ISSUE: Permit to Demolish/Capsulate (partial) and Certificate of Appropriateness for alterations and an addition

LOCATION: Old and Historic Alexandria District
706 North Washington Street

STAFF RECOMMENDATION

Figure 1: Area of exterior wall on east elevation to be demolished

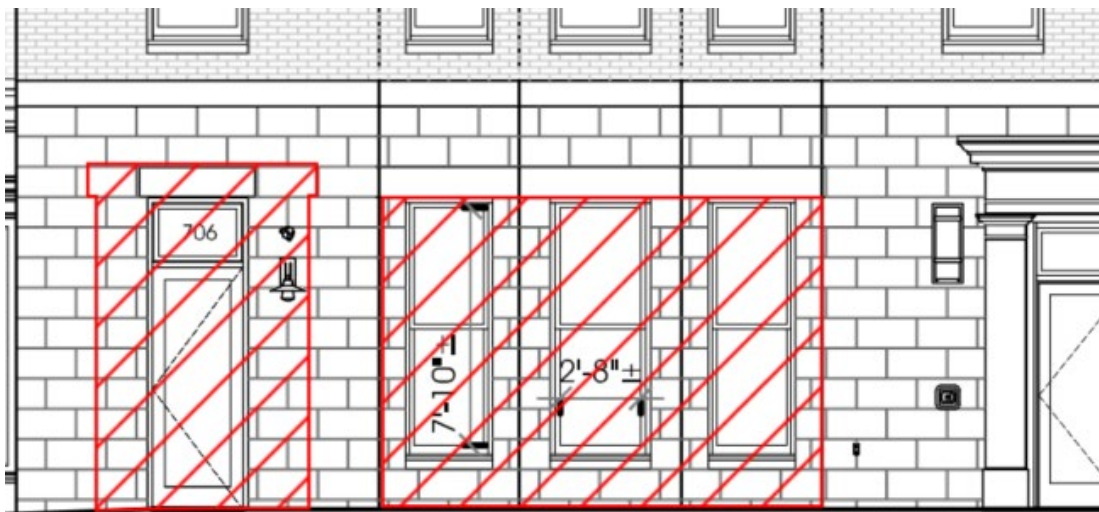
The applicant proposes to demolish the existing exterior door and an area of stonework on either side of the existing door at the south end of the east elevation. In addition, the three windows and surrounding stonework will be demolished at the ground floor of the southernmost bay on the east elevation (Figure 1).

Figure 2: Proposed new entry door and ground floor storefront windows

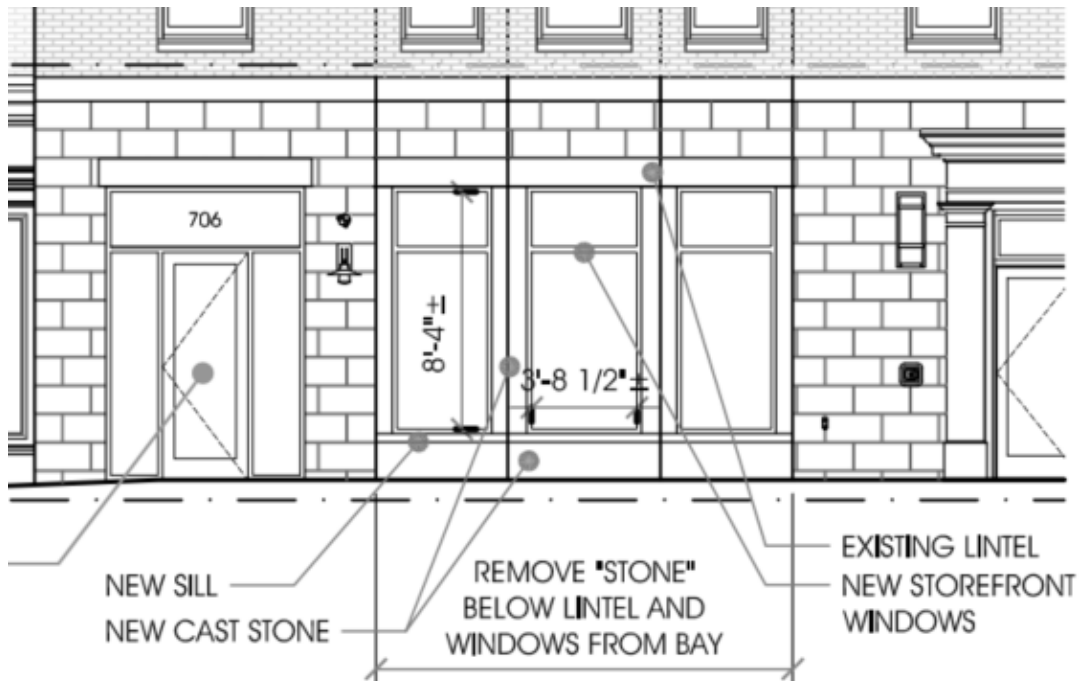
The applicant proposes to install a single storefront door with sidelights on either side and a full width transom at the location of the existing single door and transom. At the ground floor of the southernmost projecting bay, the applicant proposes to install three storefront windows, approximately 3'-8 1/2" wide by 8'-4" tall with new cast stone pieces at the sill and between the windows in order to allow for greater views into the ground floor retail space from the sidewalk (Figure 2).

PROPOSED ELEVATION

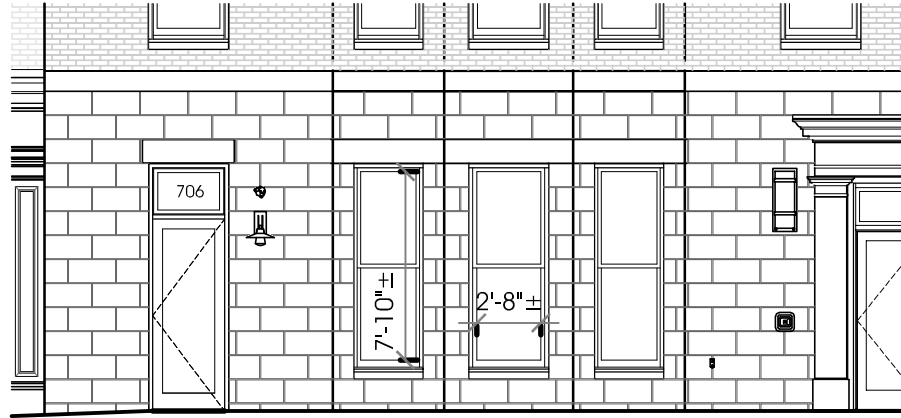
RETAIN EXISTING BAY FORM
AT FIRST FLOOR AND
EXISTING LINTEL AND STONE
ABOVE

NEW CAST STONE PIERS,
SILL AND BASE WITH
STOREFRONT WINDOWS TO
MATCH NEW ENTRY

NEW STOREFRONT ENTRY DOOR
WITH SIDELITES AND LARGER
TRANSOM

700 NW Window Options

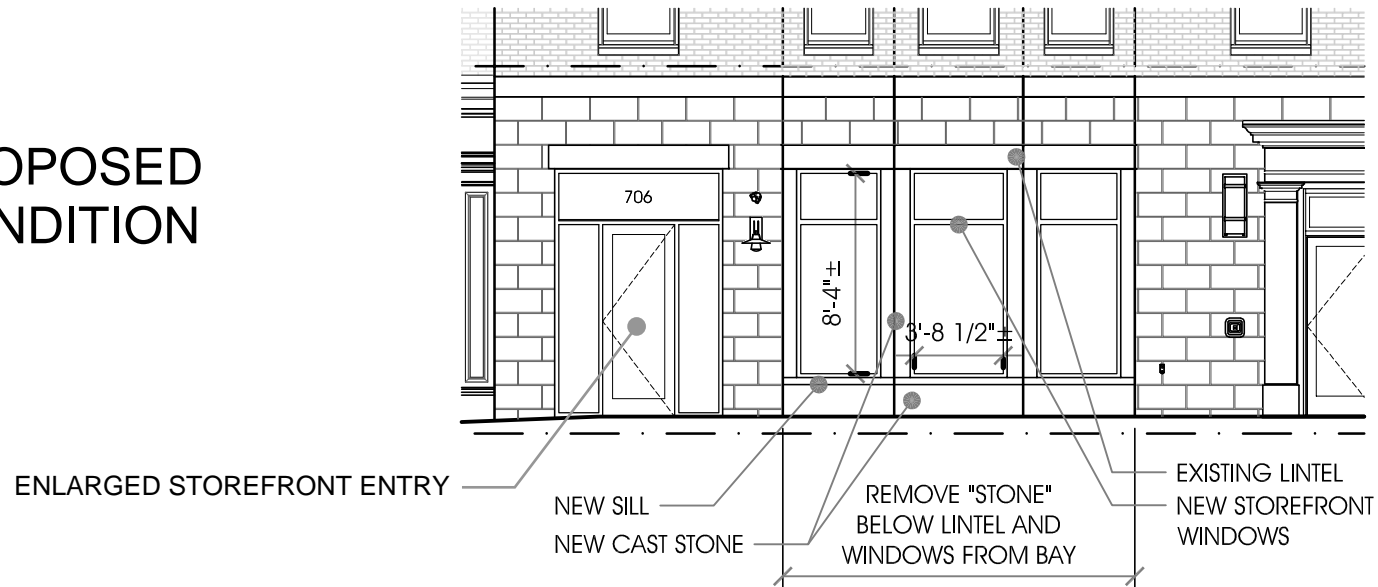
The design of the existing building is a combination of different forms with distinct architectural characteristics meant to break down the overall building massing. The portion of the building where the proposed modification is to be completed is a symmetrical, Neo-Victorian composition with two faceted projecting bays separated by two window bays with a single window bay to either side. The bays are topped by gabled dormers that project from a tiled mansard roof. While the overall building is asymmetrical in its composition, this portion of the massing relies on its symmetry as the organizing concept (Figure 5). The proposed modification will change the windows on the southernmost bay only, leaving the northern bay in its current configuration. Modifying only one of the bays and the adjacent entry door would shift the organization of the elevation with the southern portion of the building more glazed than the northern portion. This could help to transition the building from one section to the other but creates an awkward tension between the two bays. Staff recommends that in order to keep the symmetrical organization of the building, the proposed modifications to the southern bay be repeated on the northern bay.

1. The applicant modify the base of the northern bay to match the proposed revisions to the southern bay.
